FINAL PRODUCT/PROCESS CHANGE NOTIFICATION #20075Generic Copy

Issue Date: 26-Apr-2013**TITLE:** Die change for the 2SK596S-B and the 2SK596S-C**PROPOSED FIRST SHIP DATE:** 26-Jul-2013 (or earlier with customer approval)
<The actual ship date will be different by each product, please check the responsible Sales person.>**AFFECTED CHANGE CATEGORY(S):** Wafer Fabrication**FOR ANY QUESTIONS CONCERNING THIS NOTIFICATION:**Contact your local ON Semiconductor Sales Office or Kazunori Akita
<Kazunori.Akita@onsemi.com>**SAMPLES:** Contact your local ON Semiconductor Sales Office**ADDITIONAL RELIABILITY DATA:** Available
Contact your local ON Semiconductor Sales Office or Kazutoshi Kitazume
<Kazutoshi.Kitazume@onsemi.com>**NOTIFICATION TYPE:**

Die of the 2SK596 will be changed by removing a test pattern.

Chip Photo	Current Wafer	New Wafer

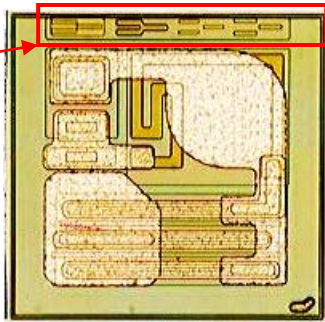
There is no change in electrical parametric performance by this die change.
